Proposal Request

PROJECT: *(name and address)*
AWSOM
Bentonville, Arkansas

PROPOSAL REQUEST 084

TBLH AV Revisions

4) ELECTRICAL

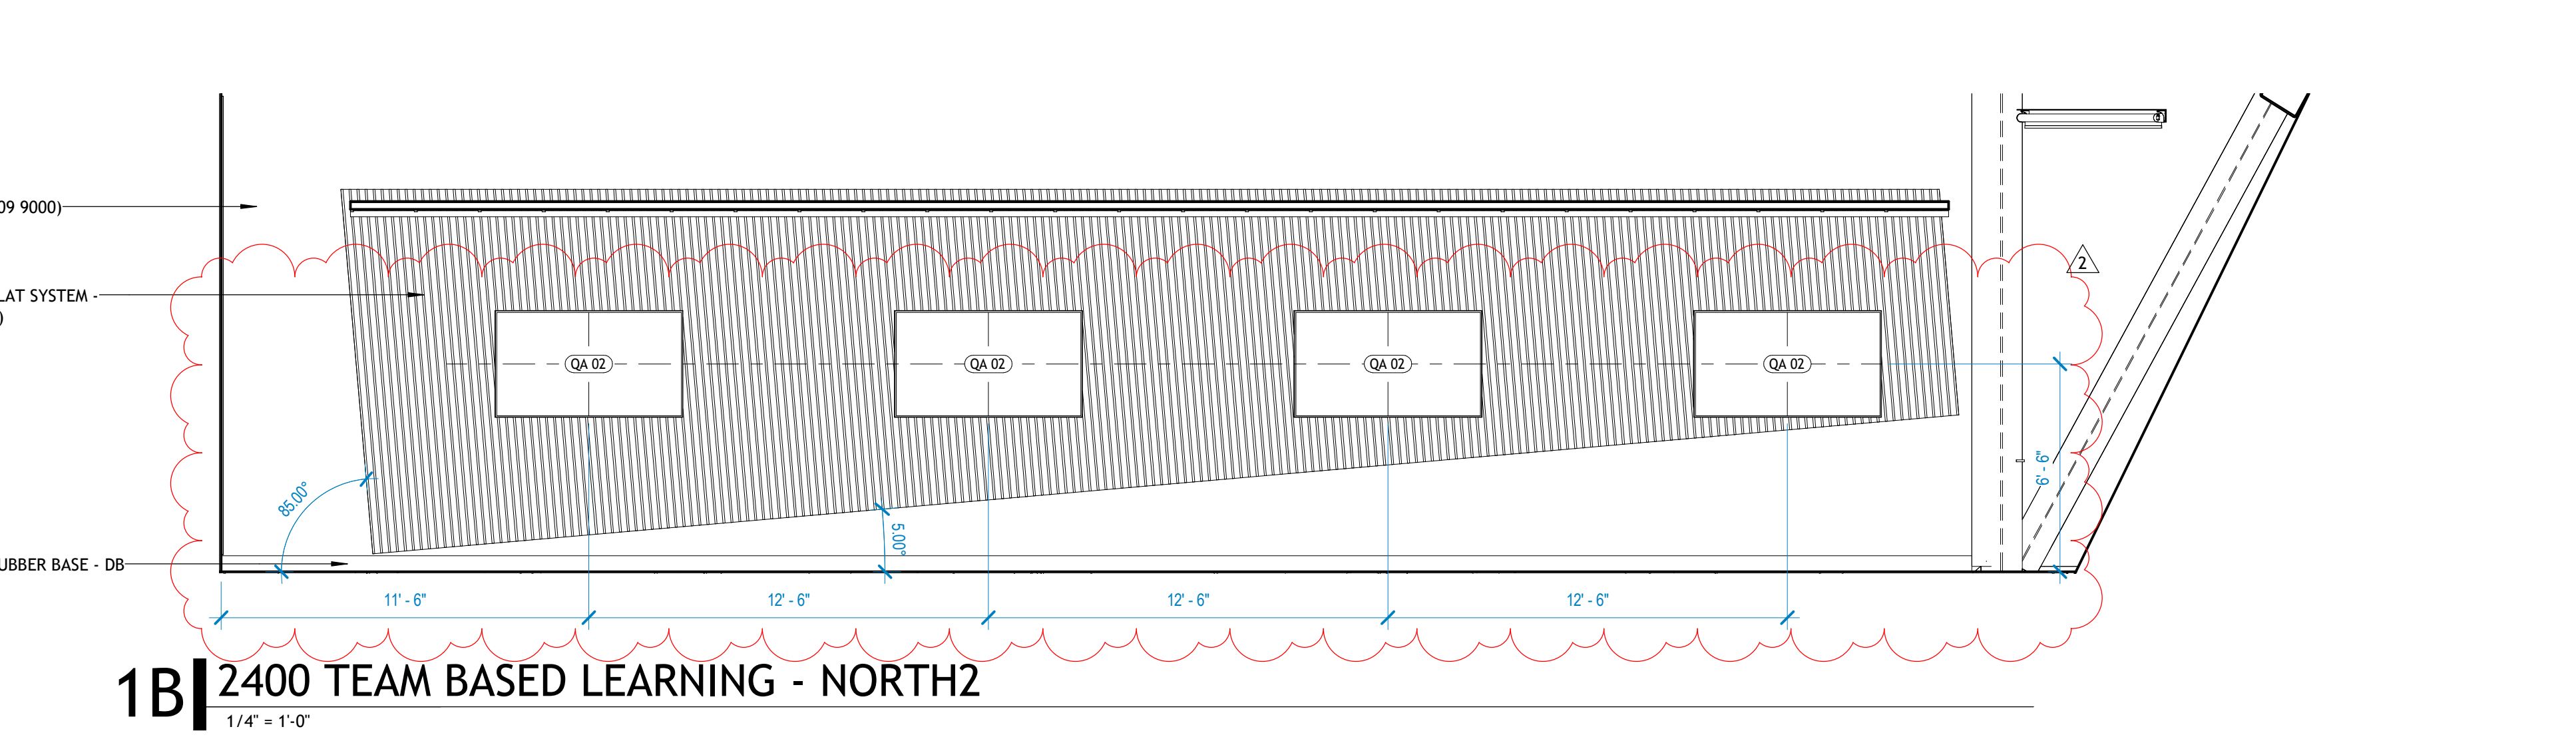
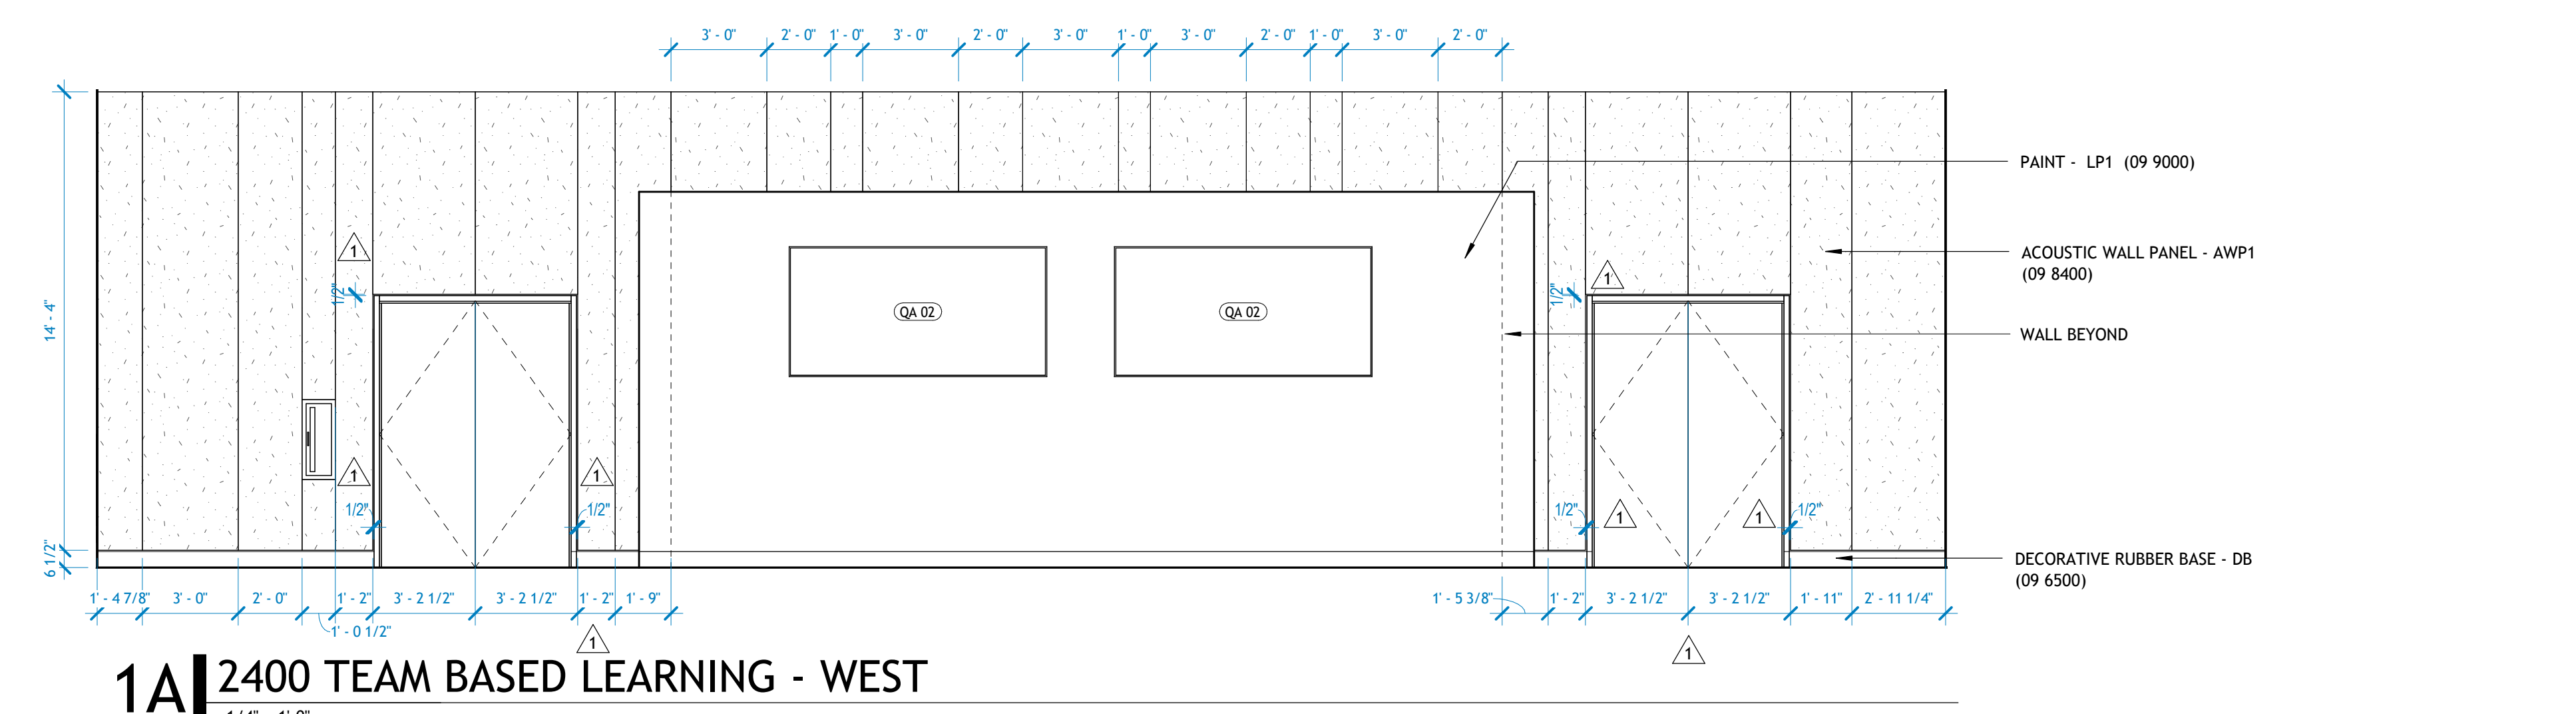
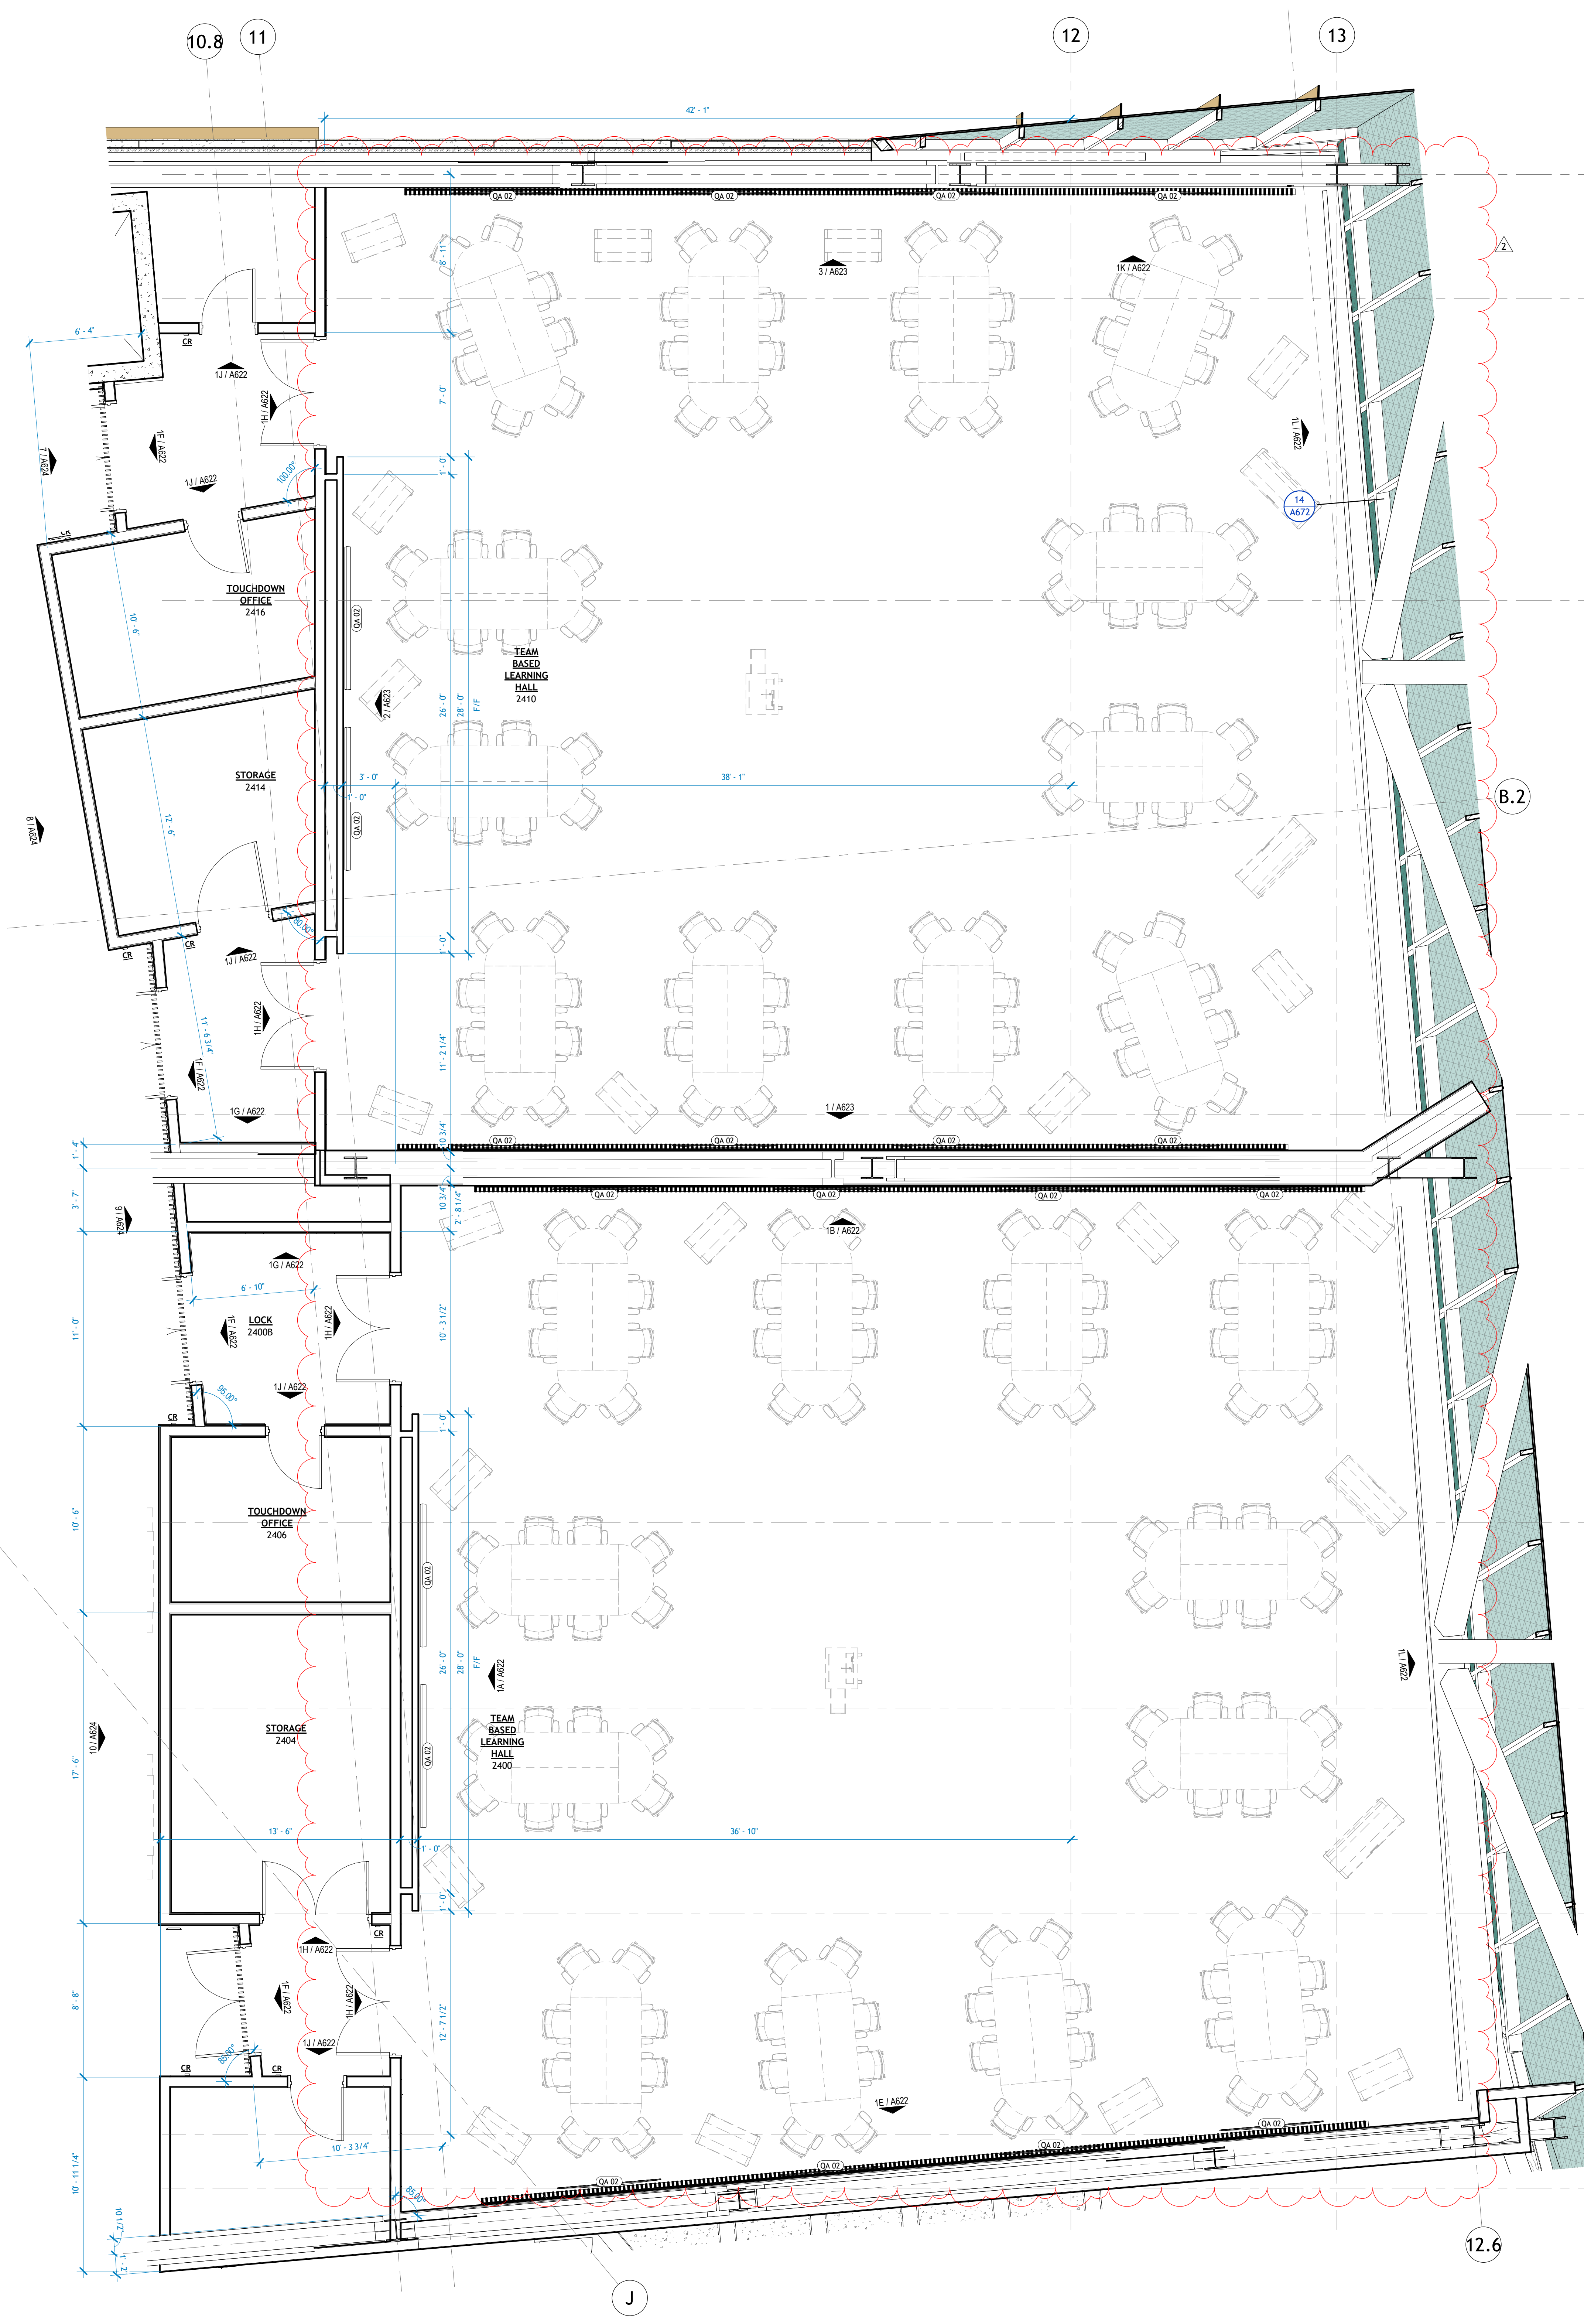
- a) Refer to Revised Sheet **A622**, with original issue date 02.24.2023 and revised date 09.25.2024.
 - Details 1, 1B, and 1E revised to show updated layout and amounts of TVs.
- b) Refer to Revised Sheet **A623**, with original issue date 02.24.2023 and revised date 09.25.2024.
 - Details 1, 2, and 3 revised to show updated layout and amounts of TVs.
- c) Refer to Revised Sheet **A912A**, with original issue date 02.24.2023 and revised date 09.25.2024.
 - Details 1, revised to show updated layout and amounts of TVs.
